PERMITTED DESIGN

PERMIT REVISION

SOUTH ELEVATION

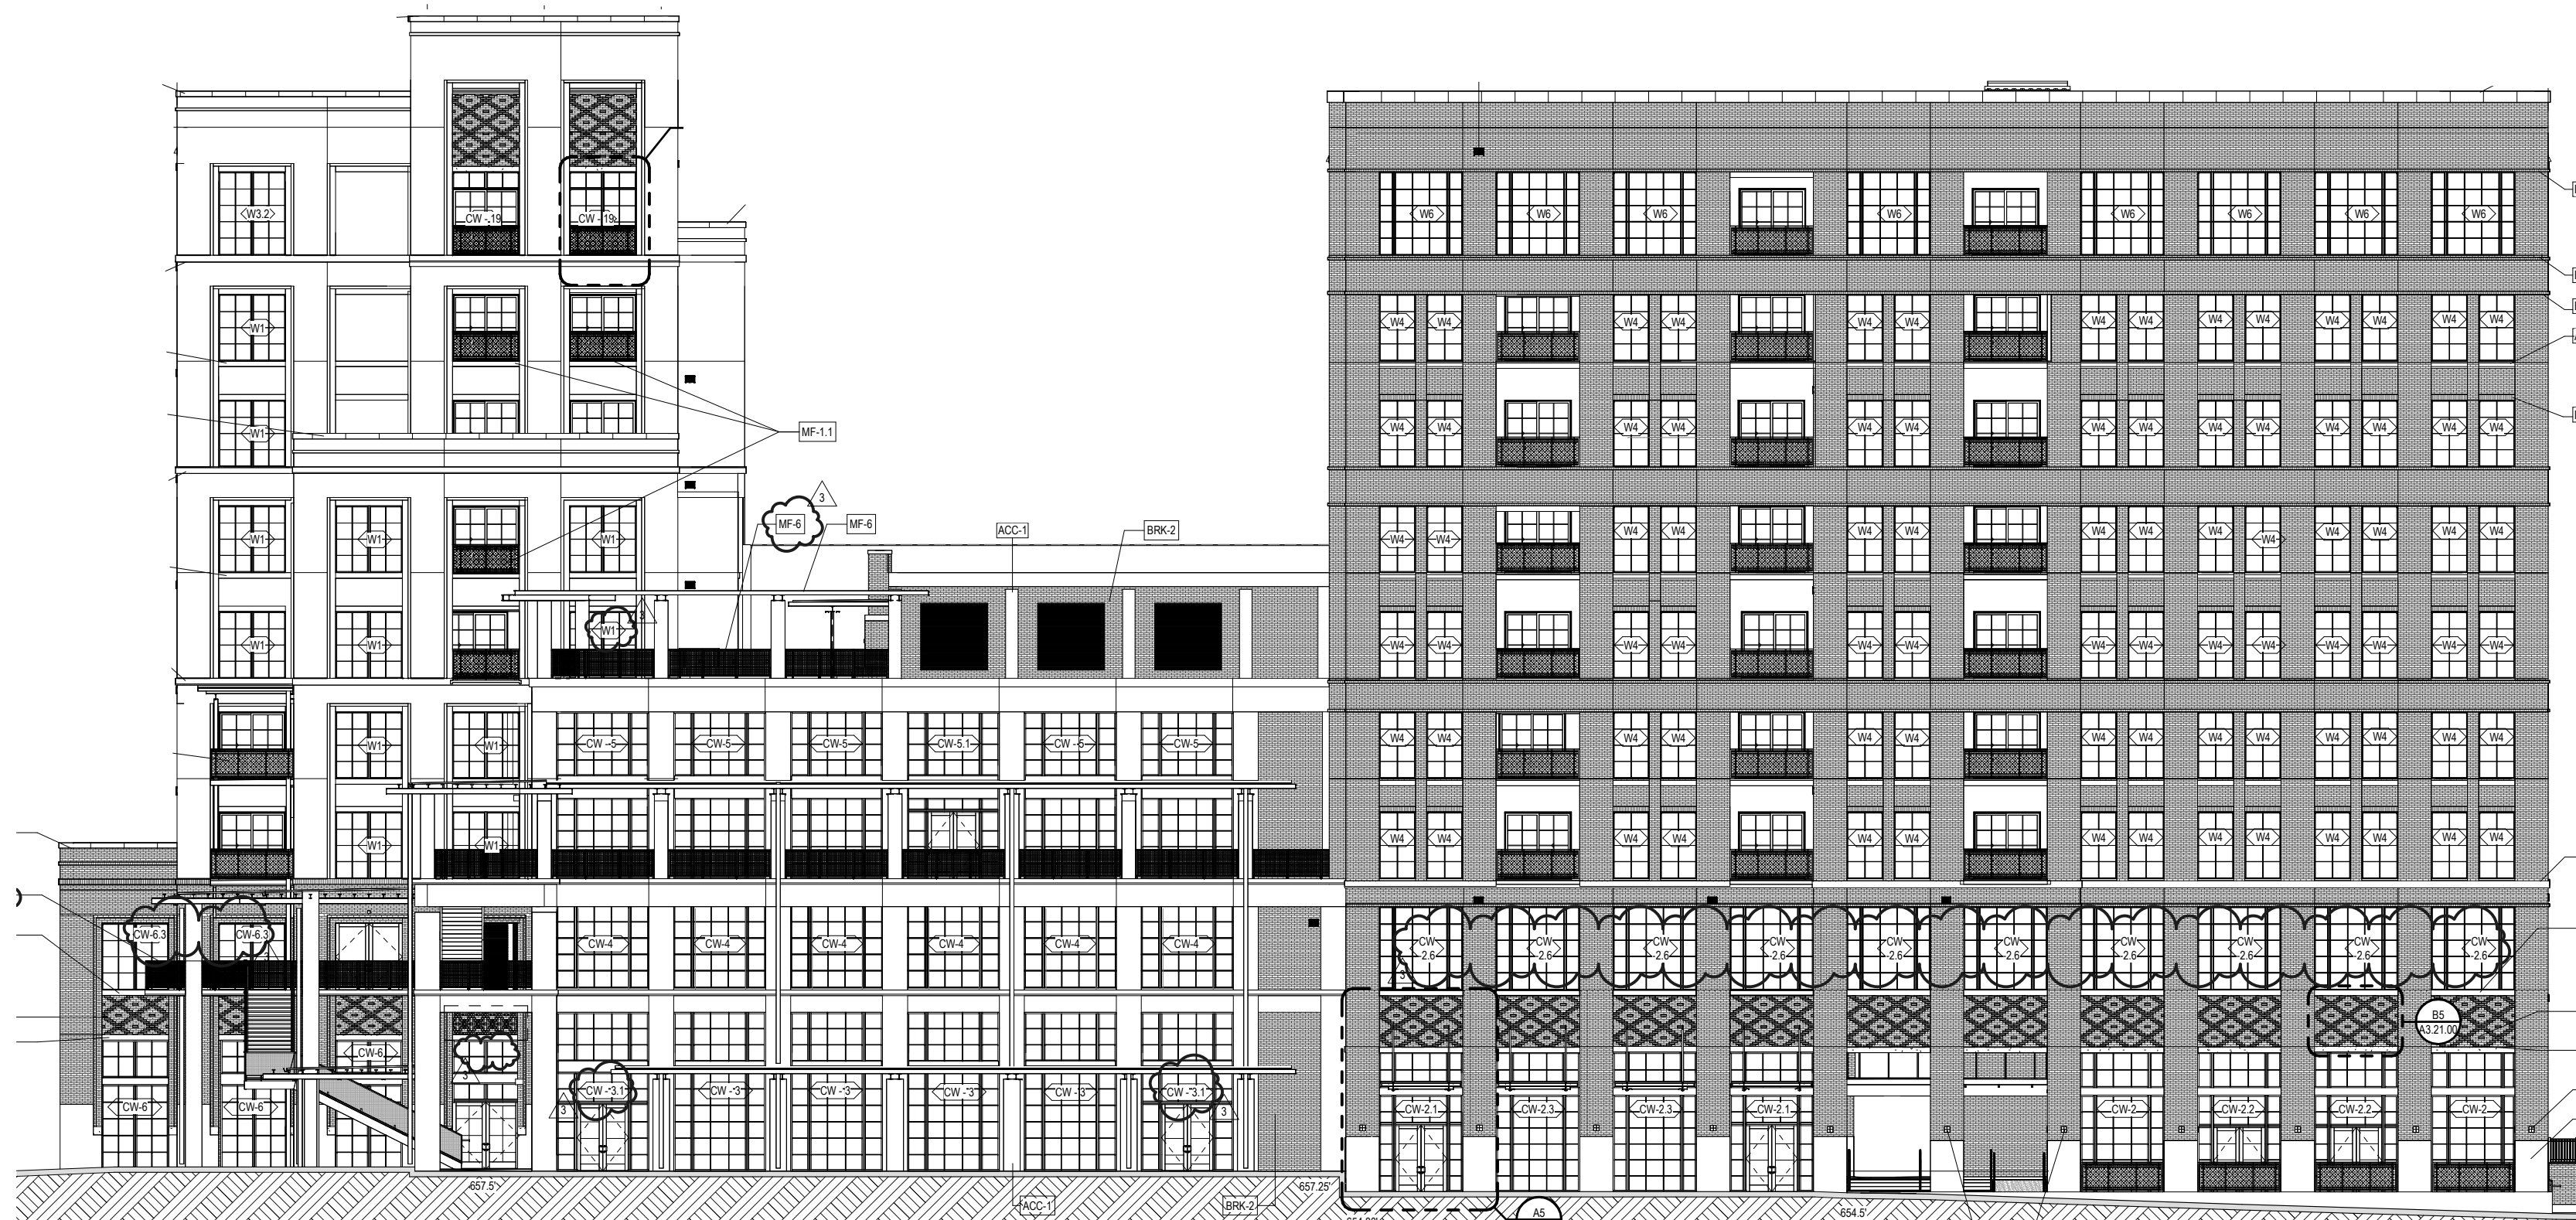
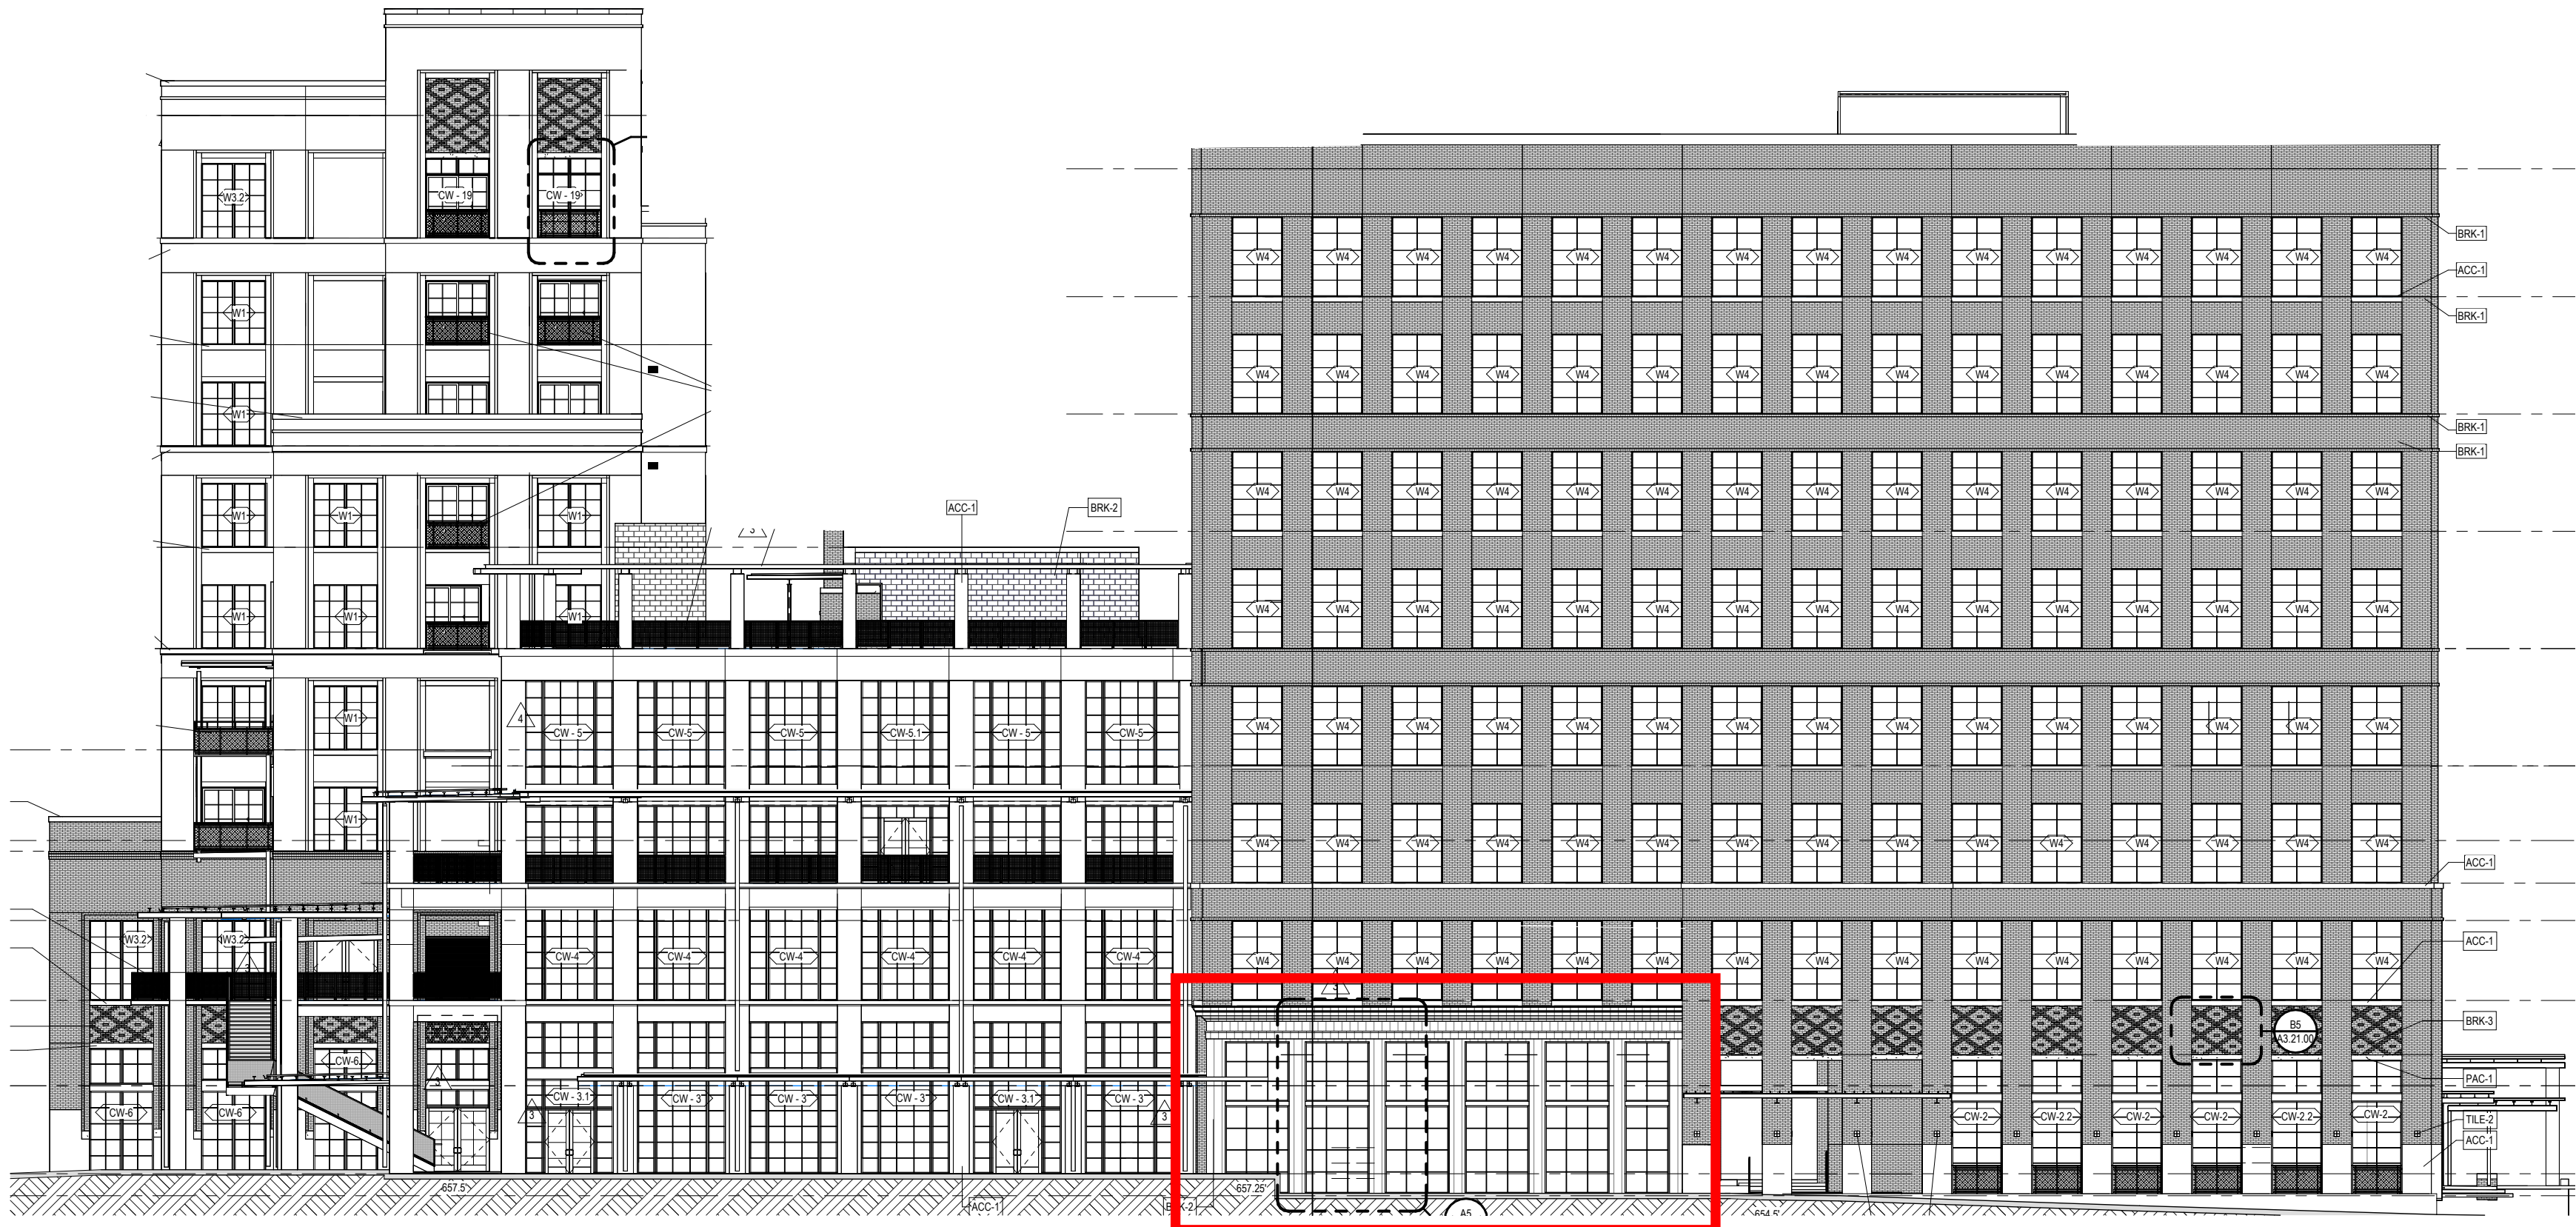
General Comments:

- Floor to floor heights revised.
- Office facade revised to remove balconies and change window spacing.
- Retail facade revised (indicated on elevation).

WEST ELEVATION

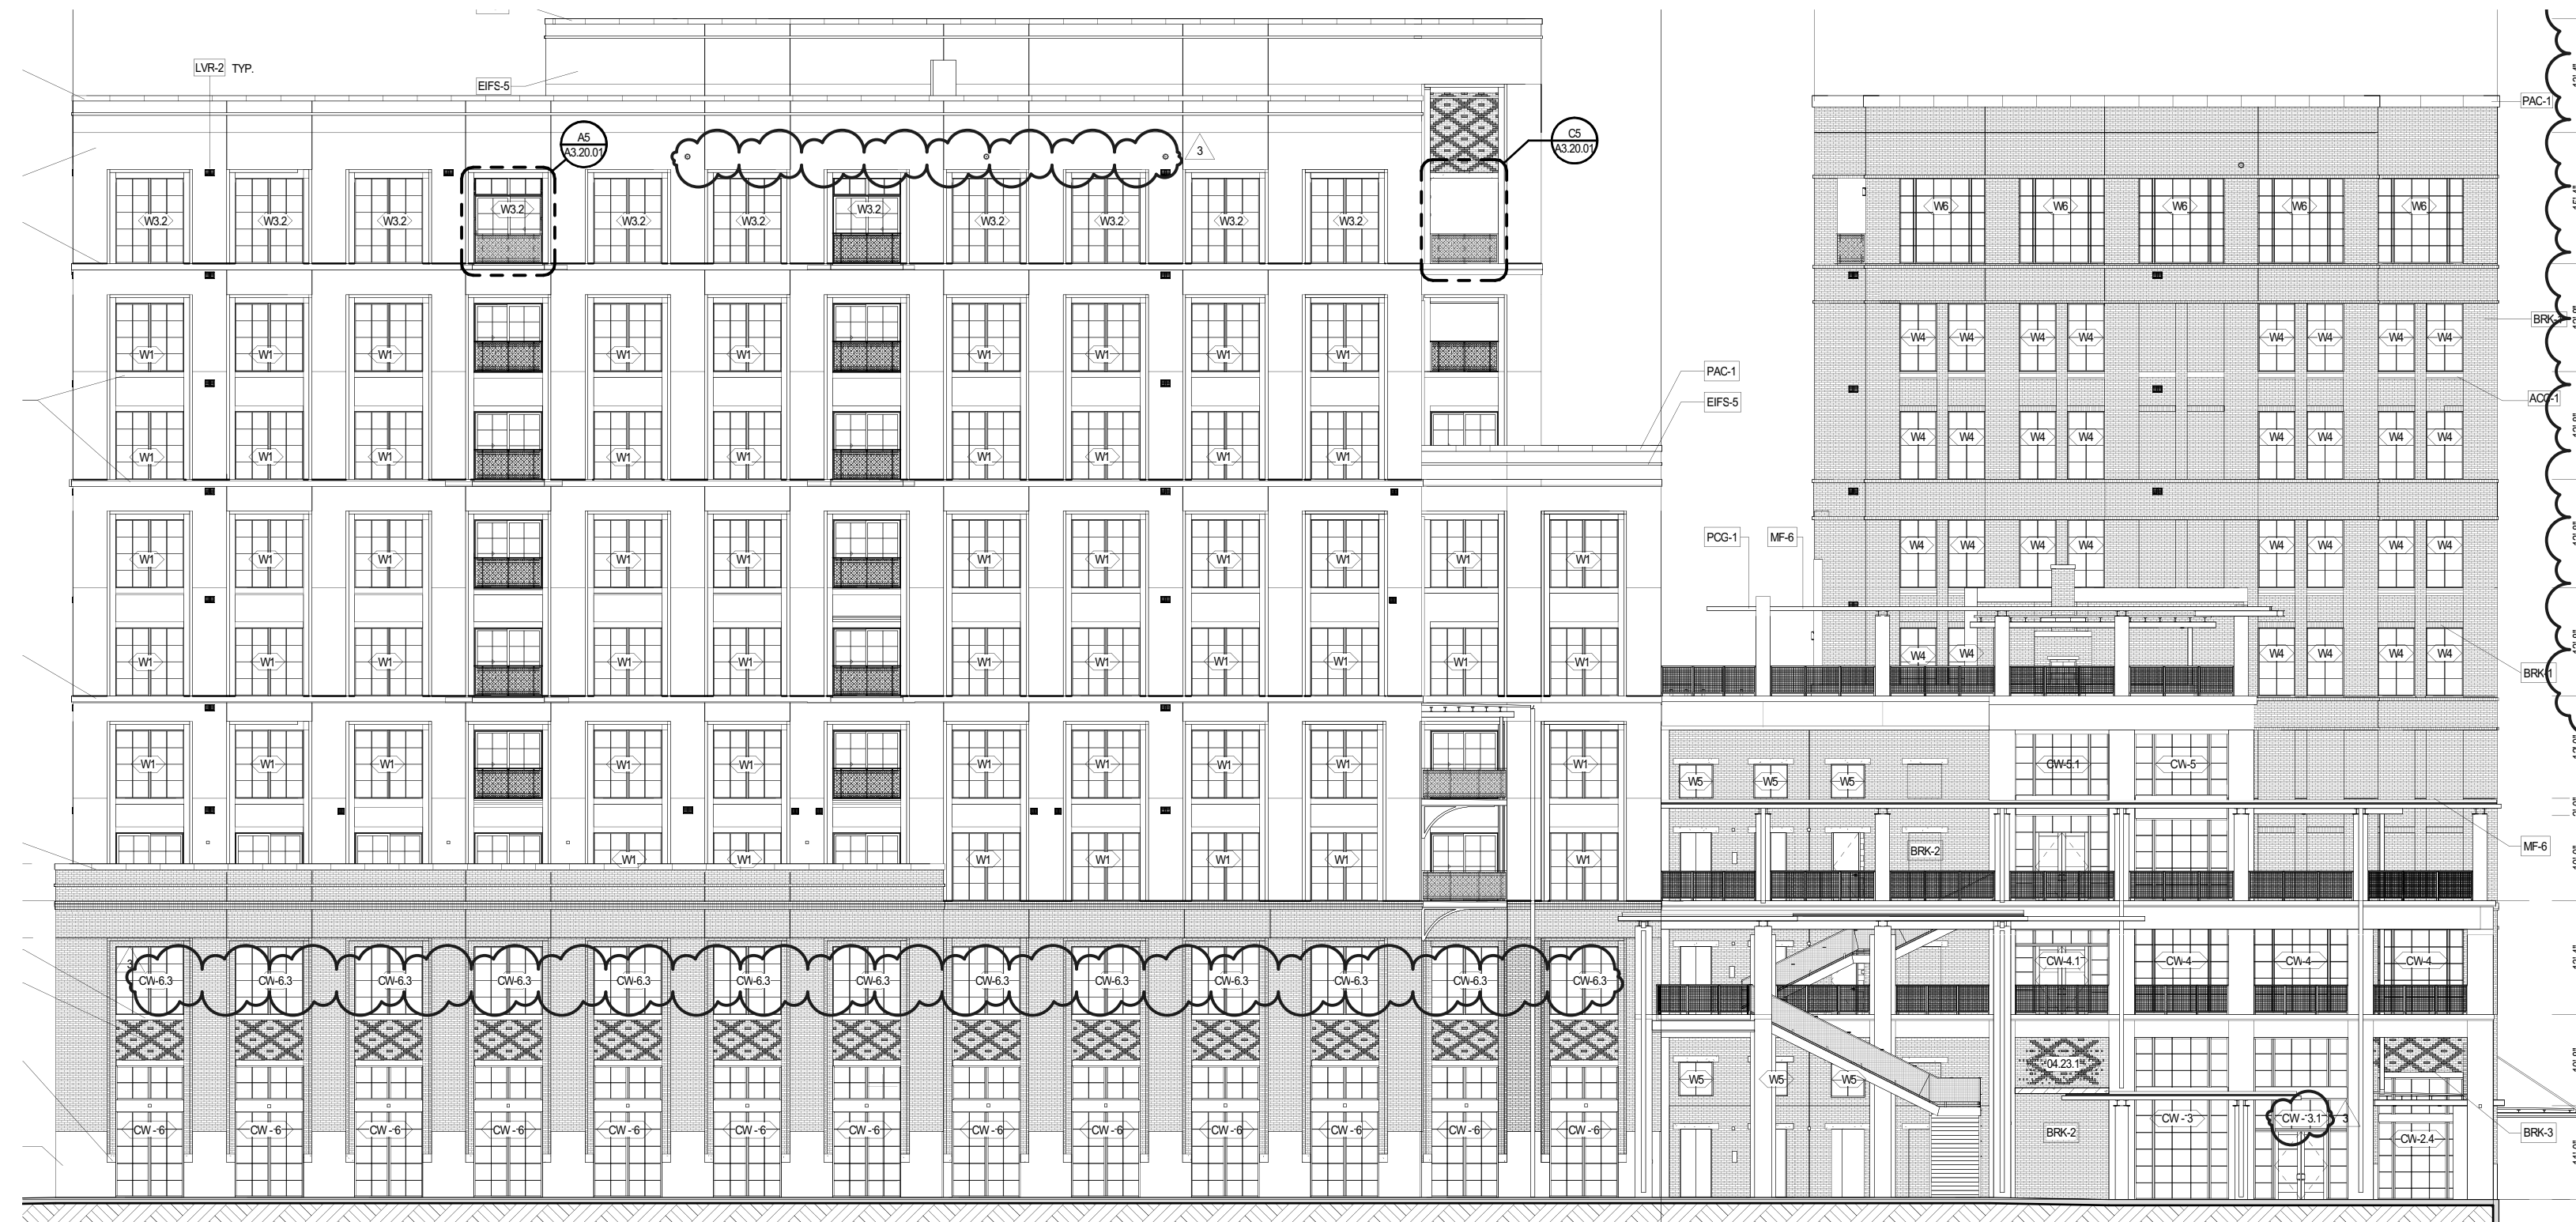
General Comments:

- Floor to floor heights revised.
- Office facade revised window spacing.
